ILLINDIS POWER COMPANY

CLINTON POWER STATION, P.O. BOX 678, CLINTON, ILLINOIS 61727

Subject: Illinois Power (IP) Company Request for Concurrence to Remove Additional Commodities from the Overinspection Program

ENCLOSURE 1 TECHNICAL JUSTIFICATION FOR IP'S REQUEST FOR NRC CONCURRENCE TO TERMINATE THE OVERINSPECTION PROGRAM FOR ADDITIONAL COMMODITIES

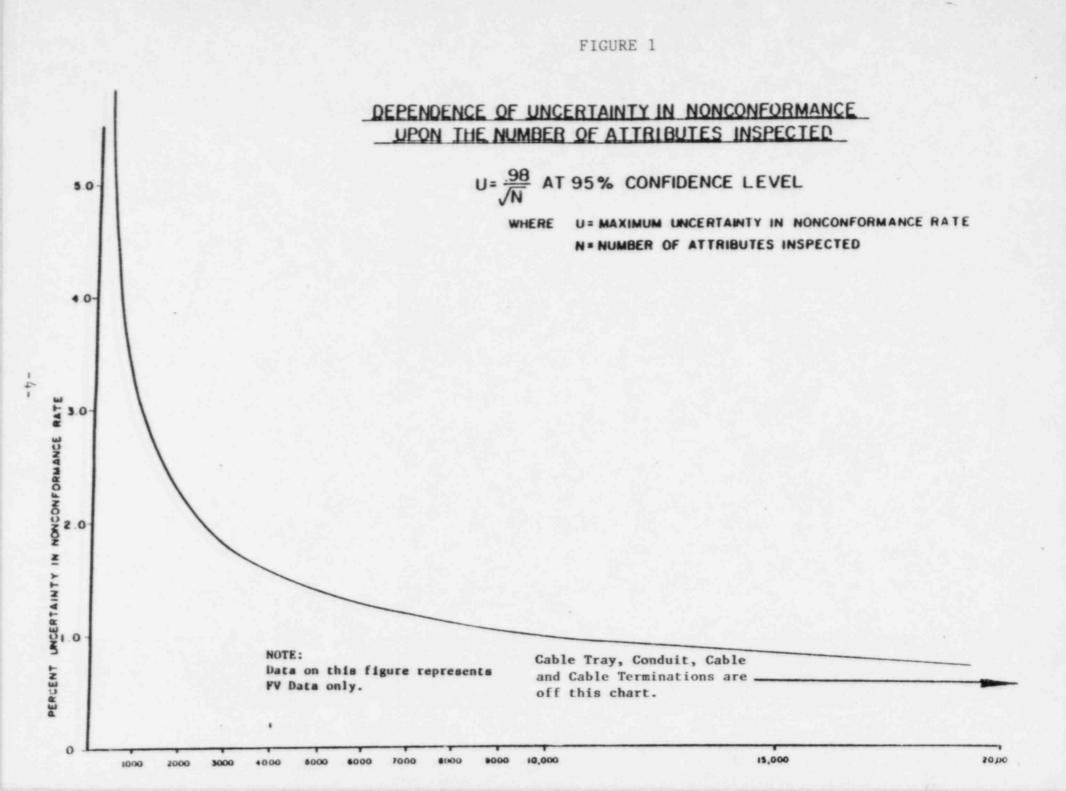
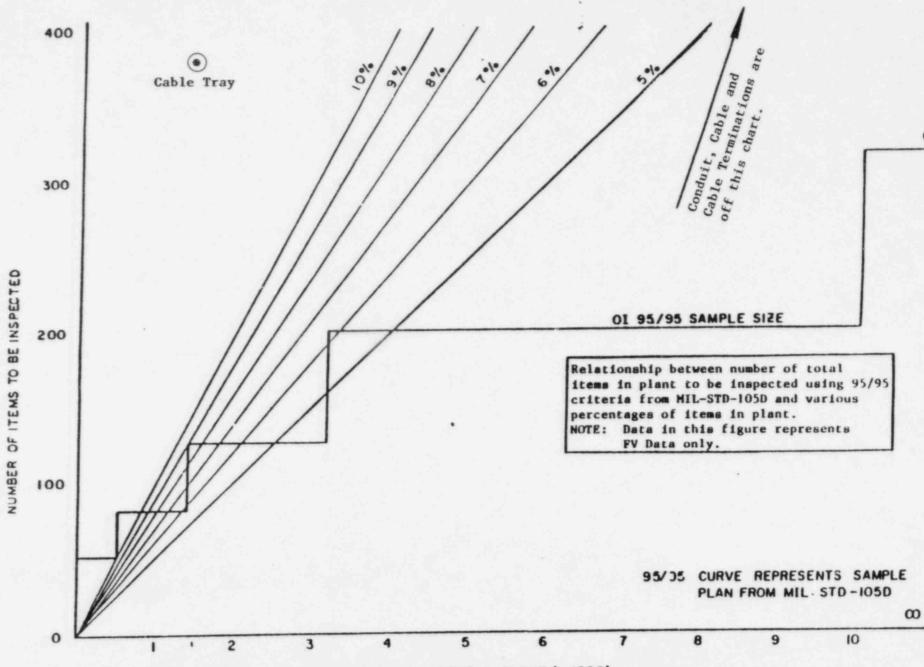
Based on the number of attributes inspected for each commodity, Figure 1 shows that the uncertainty associated with the reinspections is low, and further inspections are not expected to significantly reduce this uncertainty. In addition, Figure 2 shows that the 95/95 criterion, which is the basis for Overinspection Program sample inspection, is also satisfied for cable tray, conduit, cable and cable terminations.

Based on the number of items reinspected, the associated low uncertainties and the fact that the 95/95 criterion has been satisfied, IP Criterion 1 for termination of reinspection has been met.
